# Access Compliance Report

## Public Rights-of-Way

### (Pedestrian Signals)

Intersection ID: N/A	Main Street:	Cross Street: N/A	Location: N/A
ADA ID: 5ECE3695C618	Signal Type: One Push Button-Non APS	Overall Compliance: No	Severity Score: BTN 1: N/A BTN 2: N/A No BTN: N/A
Codes/Mitigation Info/Possible Solution		Field Measurements/Component Compliance

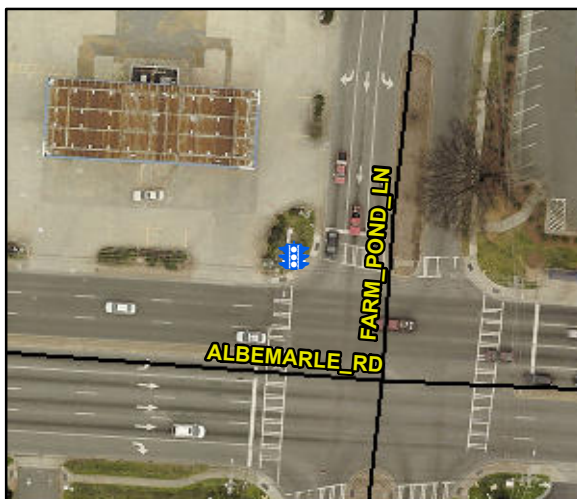
Possible Solutions: Remove & Replace Sign. Provide Push Button Extension. Remove and Replace Clear Space.

Surveyor Notes: TEXT HT 7/16

PROW/ADA: R410.6, R404.2, R406.2
